**RE: PROPOSED REDEVELOPMENT
OF HURSTVILLE PRIVATE HOSPITAL**

1. As requested, we are writing to set down our responses to matters raised by the Department of Planning following the exhibition period for the above development. We have previously prepared a report¹ which was submitted with the Part 3A application.
2. In a letter dated 10 January 2013, the Department of Planning has raised a number of matters relating to transport and accessibility. These matters, and our responses, are provided below.

TITLE:
**SITE AREA FOR TURNING
 AT UPPER BASEMENT LEVEL
 EXITING TO PEARL STREET**

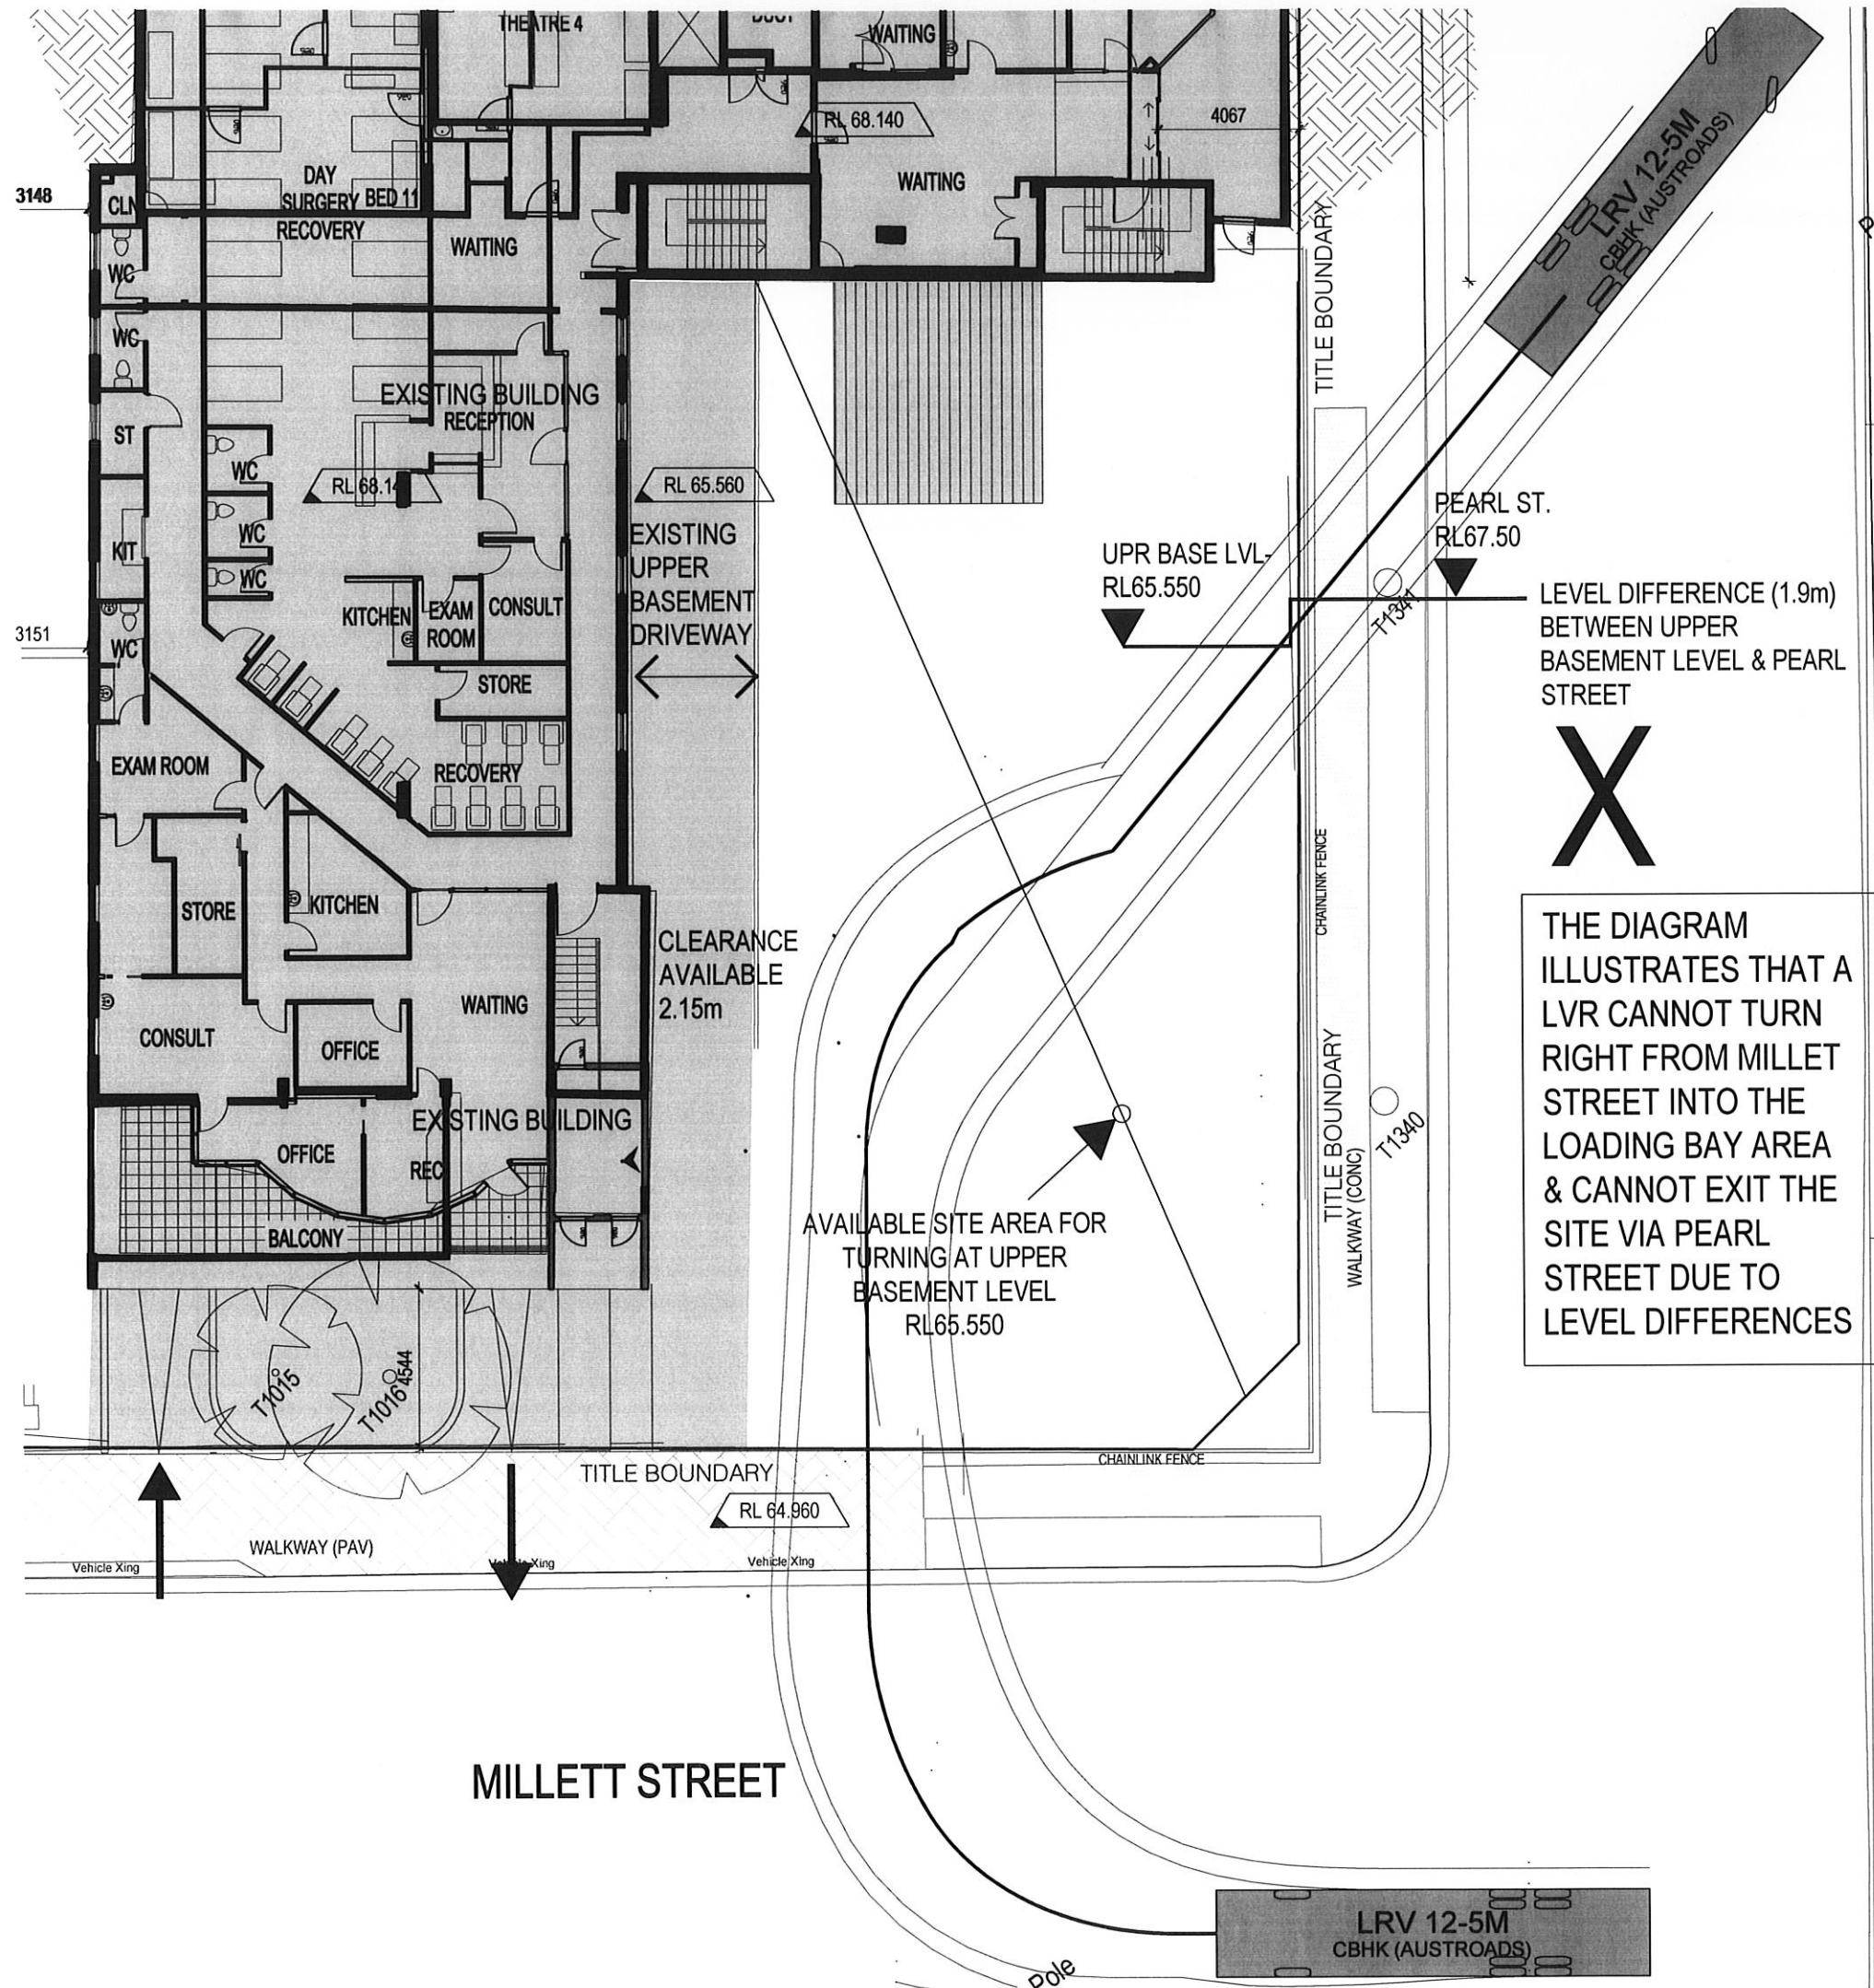
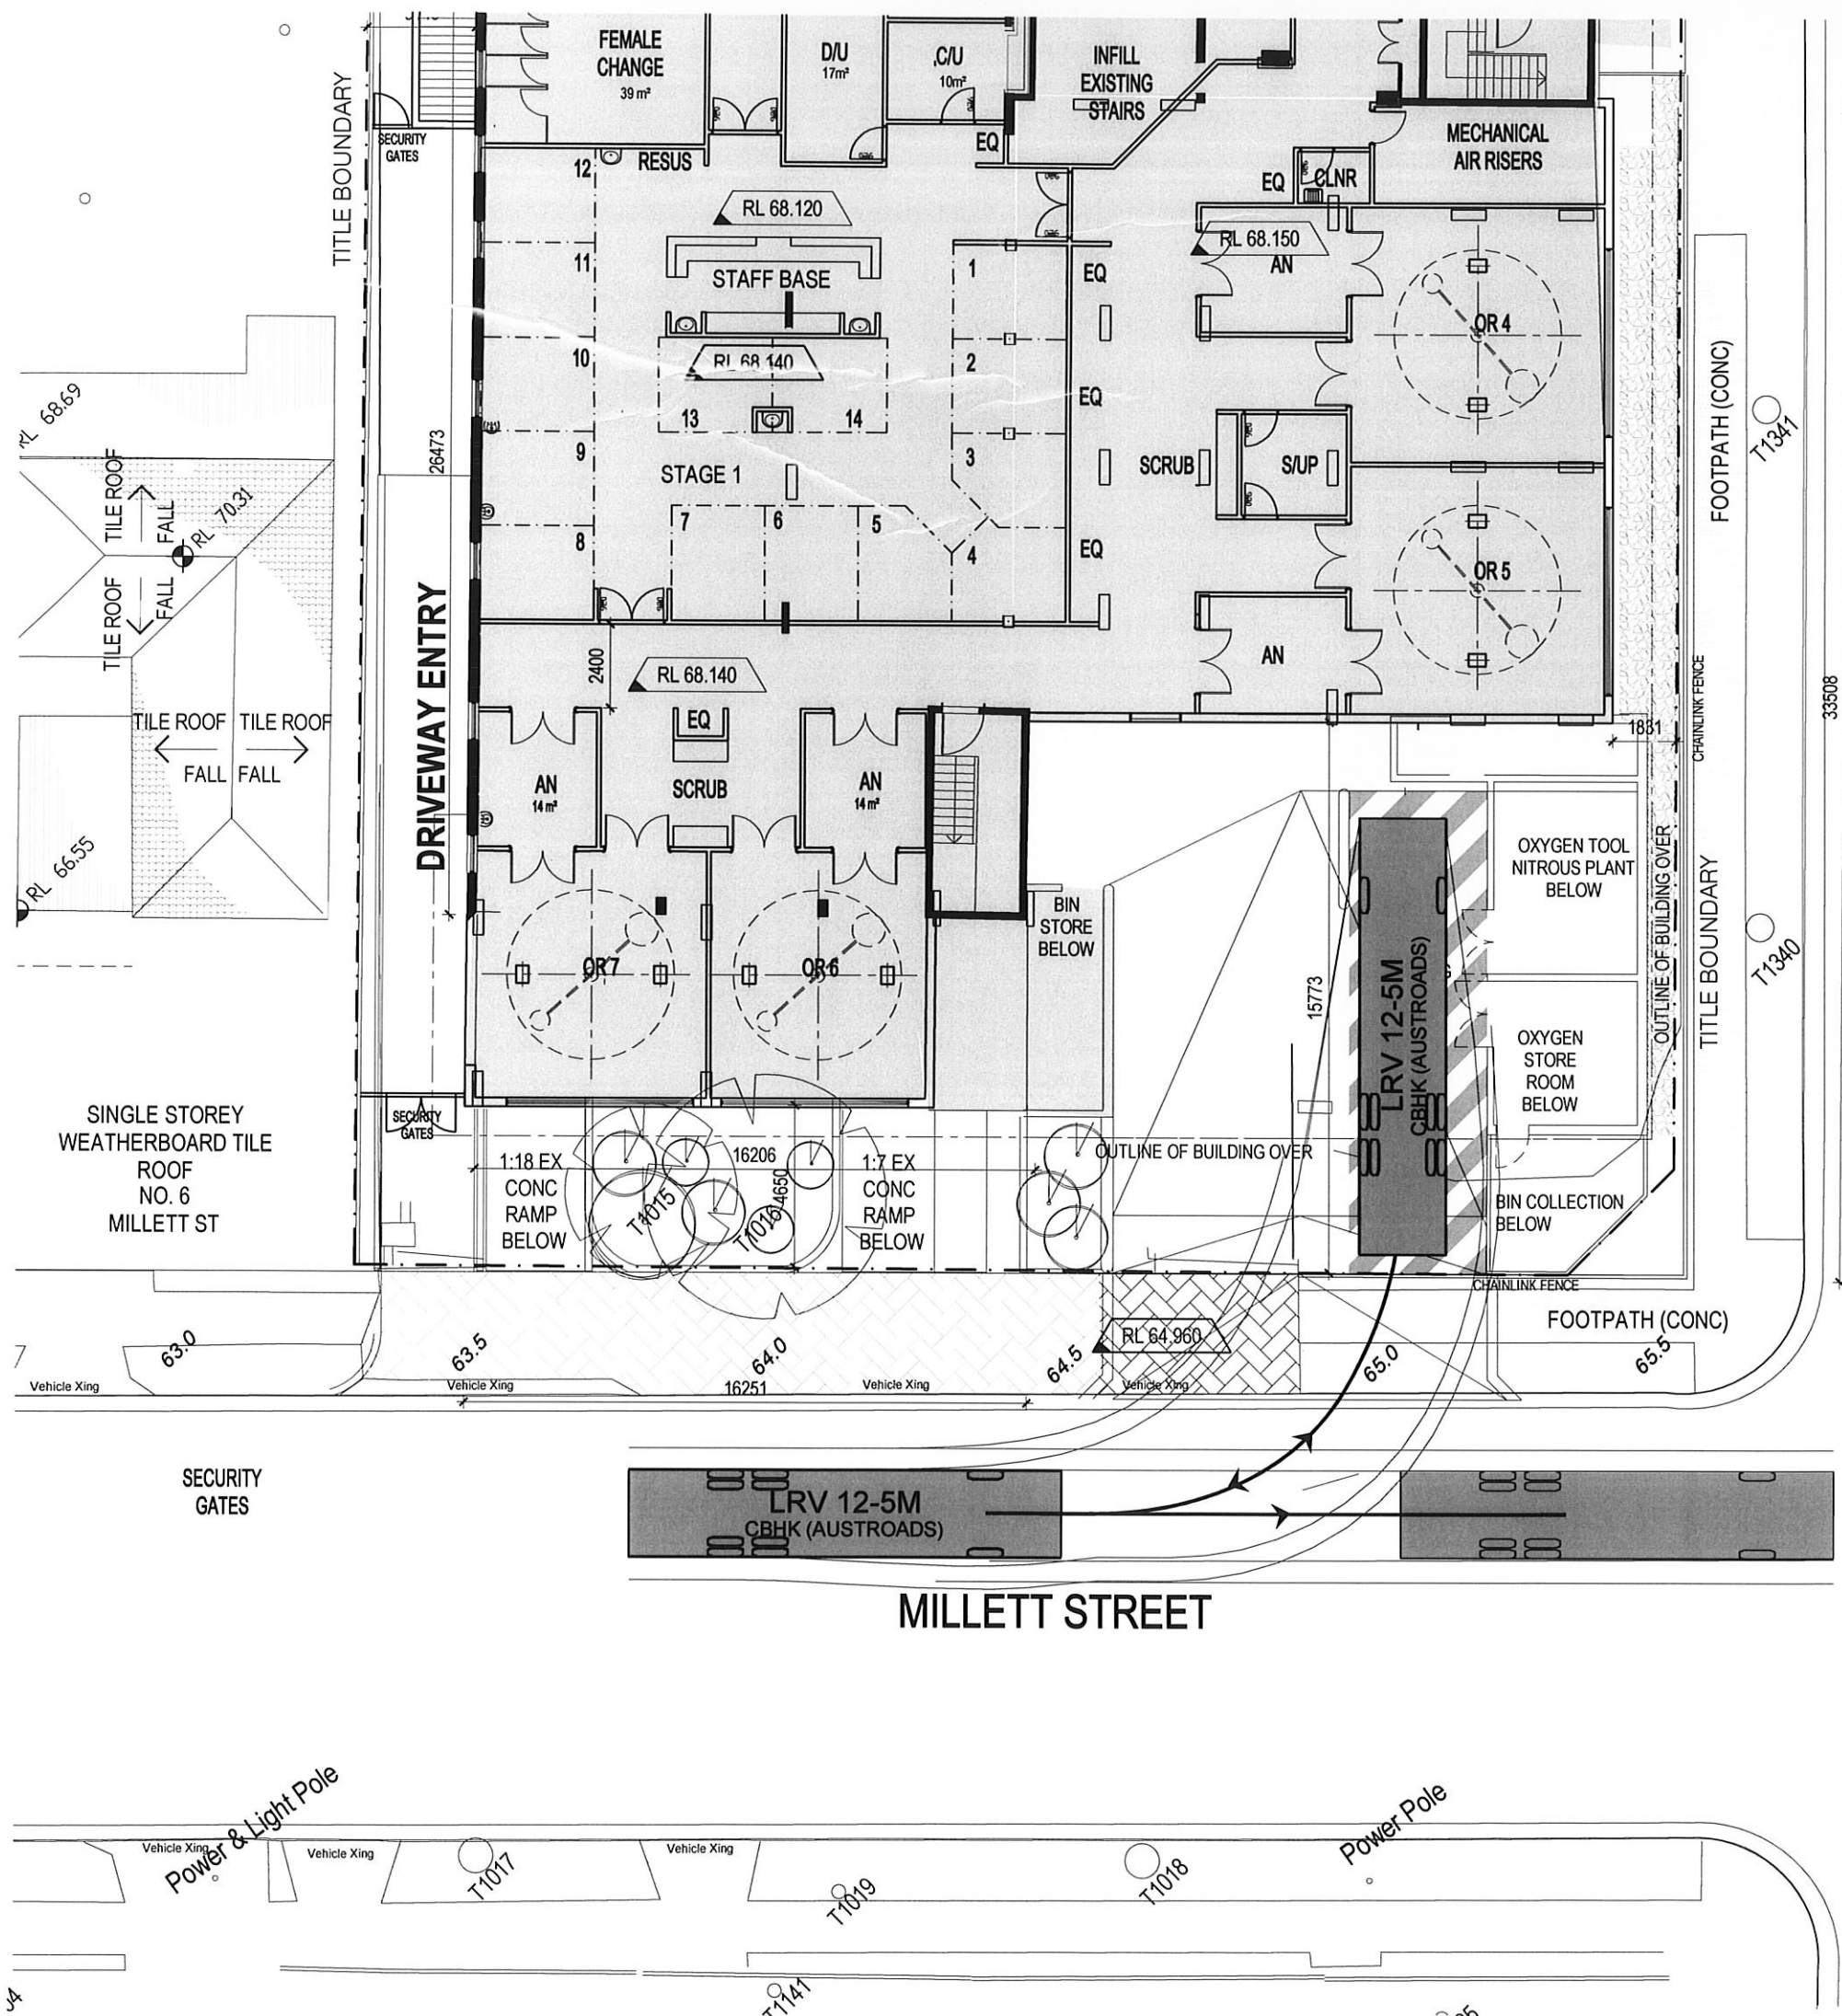
- *Provide more information about how the servicing of the proposed development is to be achieved and in particular, demonstrate how loading and unloading by vehicles is to occur in a forward direction only. If there is a need for reversing manoeuvres from Millet St, justify why the design cannot be amended to include forward only servicing and provide detailed documentation as to the frequency of any such servicing (including likely arrival and departure times and vehicle type) and that the frequency is in accordance with the Australian Standard for Parking Facilities by specific reference to relevant provisions.*
10. The first part of this matter is being addressed by the project architect. To provide for large service vehicles to enter and exit the site in a forward

direction, part of the existing car park and building fronting Millett Street would need to be demolished, as demonstrated in the attached drawings (DA-080, DA-081 and DA-082) prepared by the architect.

THE DIAGRAM ILLUSTRATES THAT A LRV CANNOT TURN RIGHT FROM MILLETT STREET INTO THE LOADING BAY AREA & CANNOT EXIT THE SITE VIA PEARL STREET DUE TO LEVEL DIFFERENCES
